**Section 16 Planning Application for Proposed Minor Relaxation of Building Height
Restriction for the Urban Renewal Authority
To Kwa Wan Road/ Wing Kwong Street Development Scheme ("KC-016")
Planning Application No. A/K9/289
- Submission of Response-to-Departmental Comments -**

Responses to Departmental Comments Table

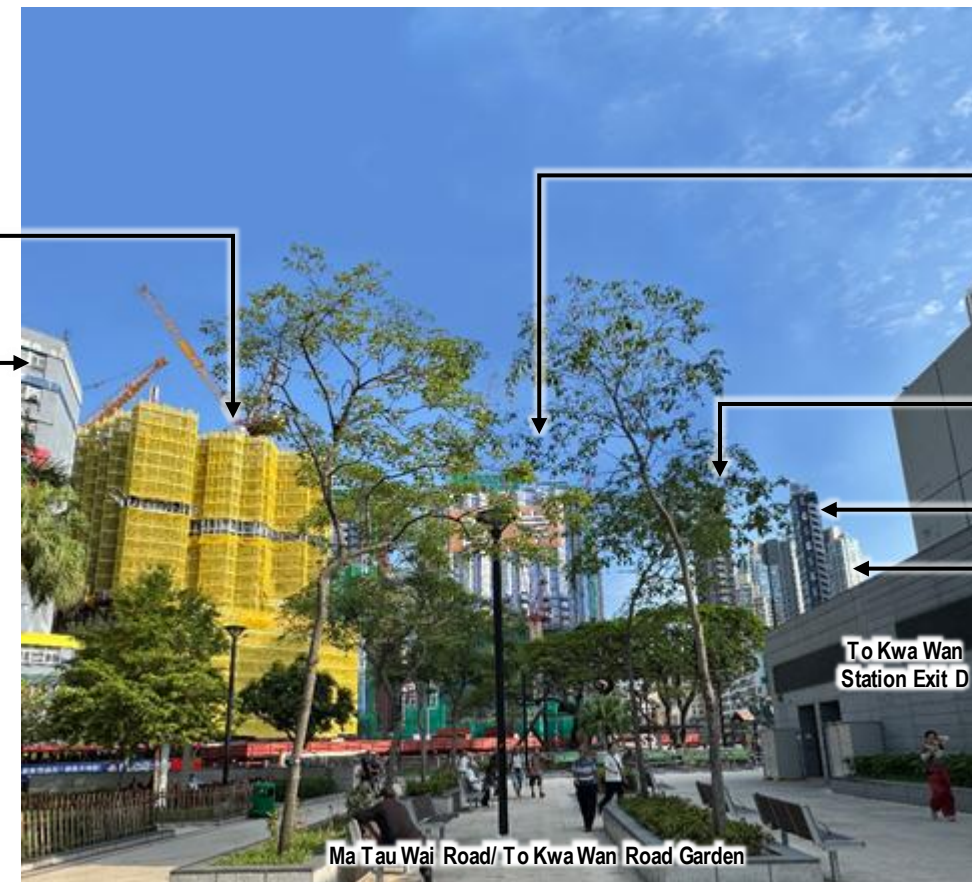
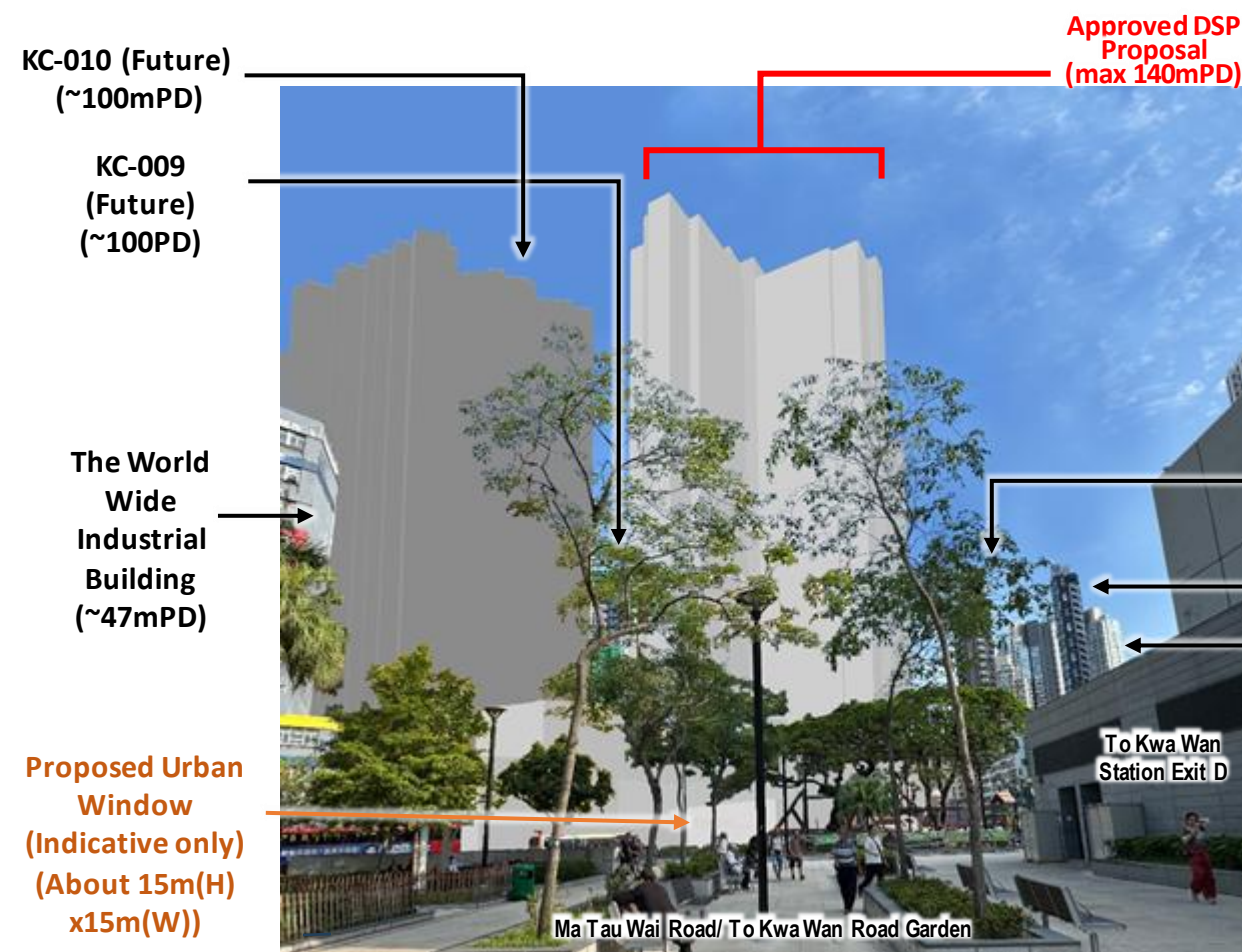
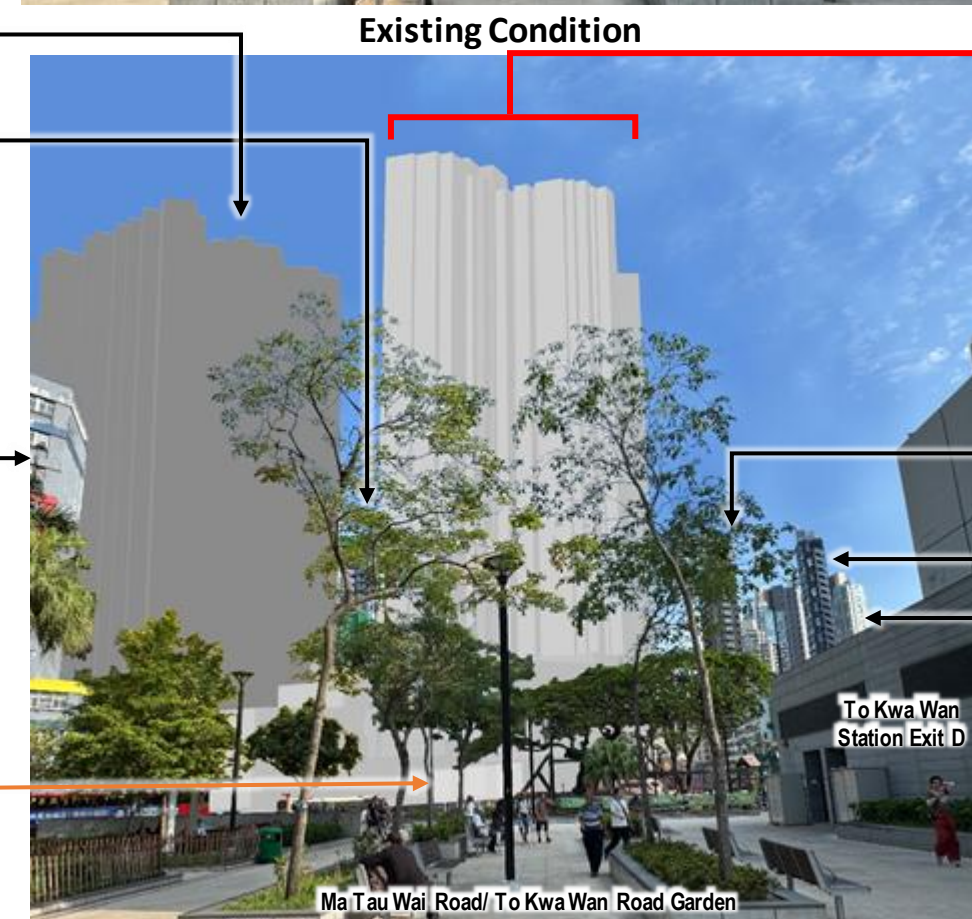
Departmental Comment	Responses
ii. VP2 – upon our checking, the proposed development under the Notional Scheme and approved DSP Proposal appears to be shorter and slimmer; and iii. according to the Explanatory Statement of the approved DSP, two intervening spaces/ urban windows design with a minimum dimensions of not less than 15m in height and 15m in width, excluding architectural features, open-side deck and circulation, will be provided at the podia, where appropriate and practicable, in the proposed development. Hence, the dimensions of the two intervening spaces/urban windows along the podia should be supplemented in the VA.	Noted. Figure 5.2 is updated and provided in the replacement pages of the VA (See Appendix 1). Noted. Para 2.3 a) and visual change of VP2 under Table 5.1 are updated to include the minimum dimensions according to the DSP, and Figure 5.2 is also revised to better reflect the proposed urban windows (see Appendix 1).

NOTIONAL BLOCK PLAN

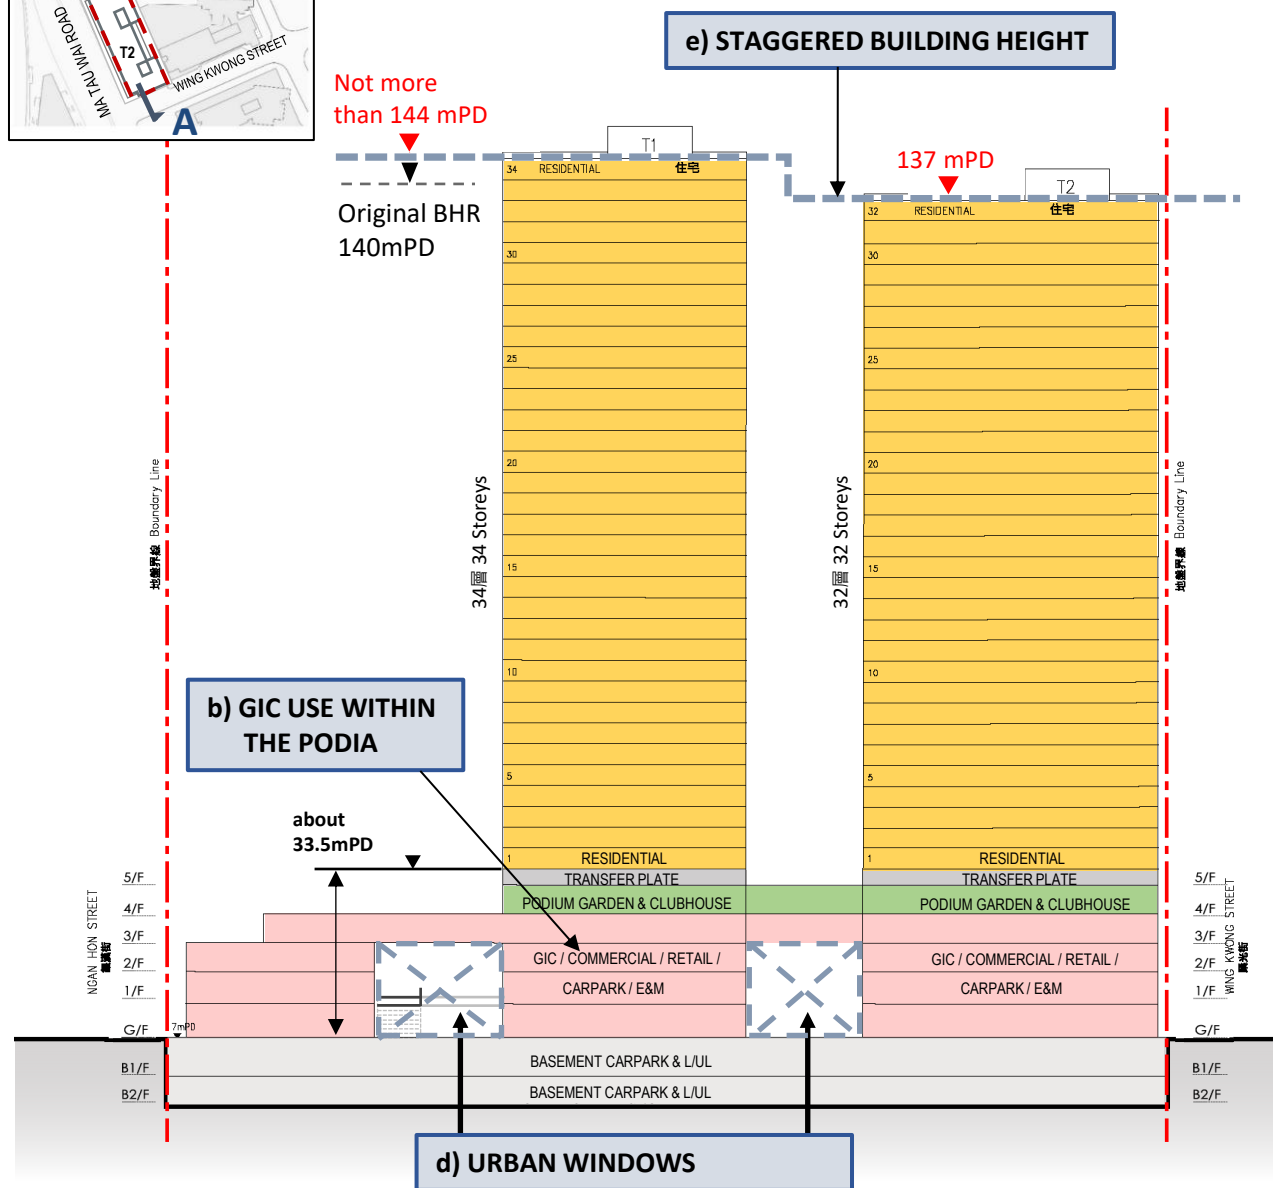
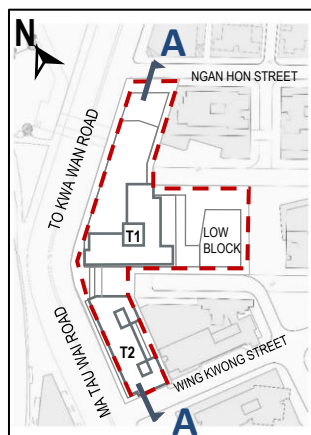
The Notional Block Plan (Figure 3.1) and Notional Section Plan (Figure 3.2) have been updated to realign the numbering of the labelling of the retained planning gains from Approved DSP and to correct a minor typo, and an additional Section Plan (Figure 3.3) has been provided to illustrate the notional design of the low-rise commercial/ retail block (i.e. the “Low Block”), as provided in the replacement pages of the Planning Statement in **Appendix 3**. The updated Notional Block Plan and Notional Section Plans will supersede those previously included in all technical assessments. This update will not affect the assessments/results of all previous submitted technical assessments.
